SERVICE BULLETIN

SB00.06

Machines/Models: TL49

PURPOSE: Enhance performance of the Main Hydraulic and Outrigger Hydraulic Manifold Cartridge Valves.

Figure 1

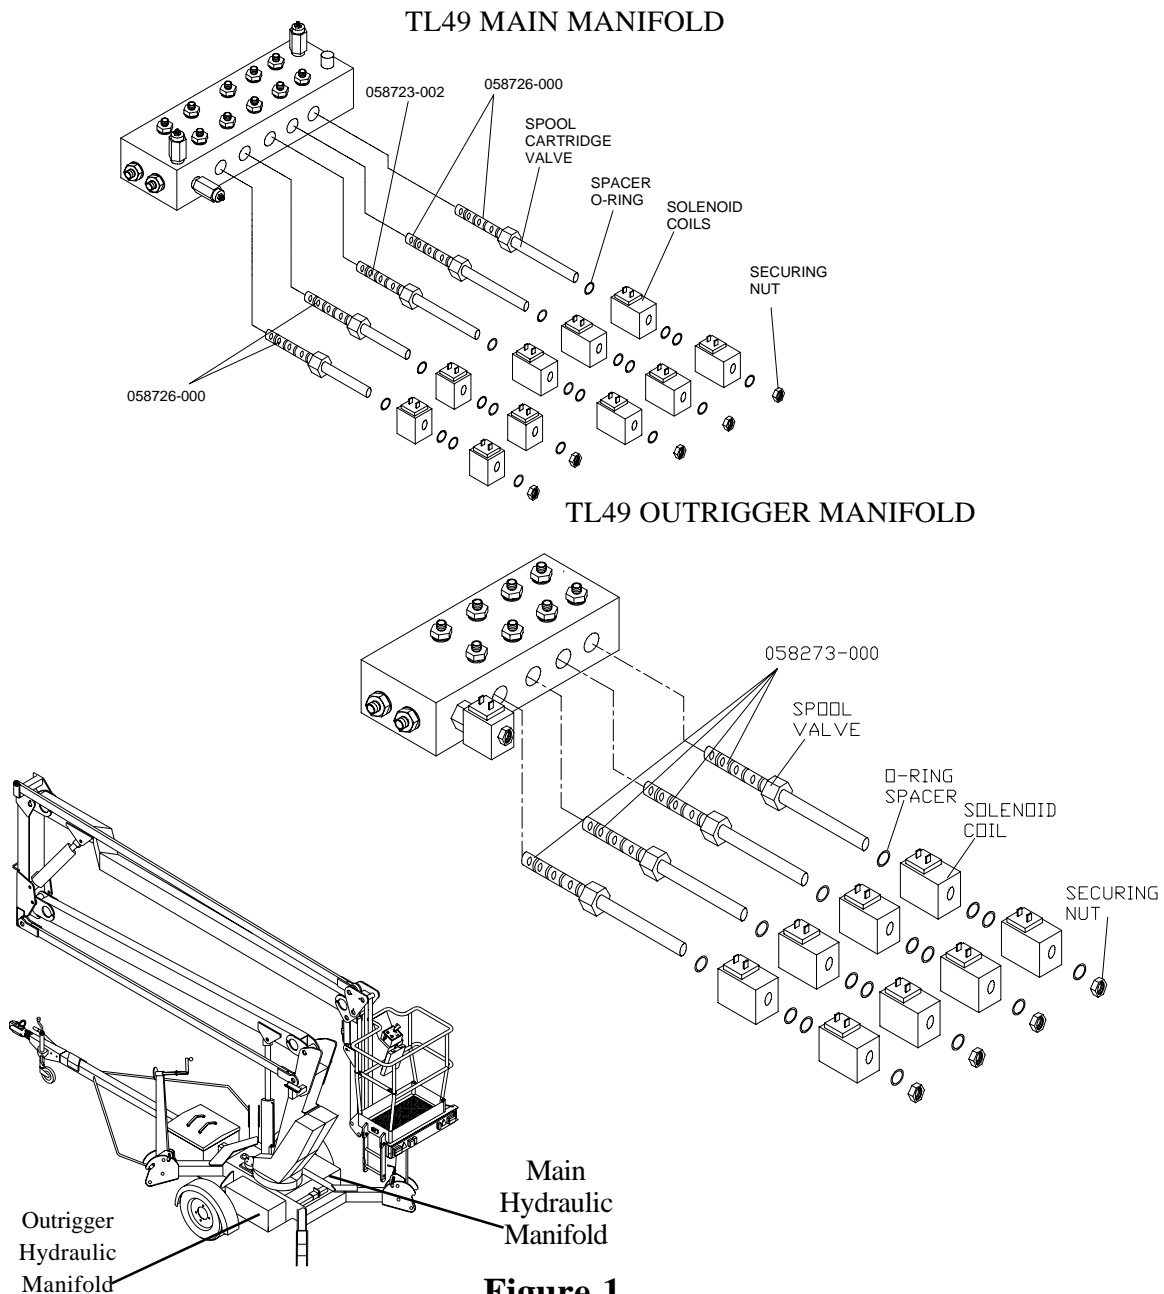
OPERATION REQUIRED: Replace the Cartridge Valves on the Main Hydraulic and Outrigger Hydraulic Manifold.

4 each - Cartridge Valve (058723-000) (S270 Valve Identifier)

4 each - Cartridge Valve (058726-000) (S271 Valve Identifier)

1 each - Cartridge Valve (058723-002) (S272 Valve Identifier)

NOTE: Verify that the correct part number valve is being installed per Fig 1.

6. Install the Supplied Cartridge Valve and torque to 25-30 Ft. Lbs. (34-41 Nm).
7. Install the Valve Coil, Spacer O-Rings and Knurled Securing Nut removed in step 4 and tighten finger tight.
8. Repeat the above operation for all Cartridge Valves to be changed.
9. Reinstall chassis covers and secure.
10. Perform the Pre-Operation and Safety Inspection as instructed in the Operator Manual to ensure proper operation of machine.
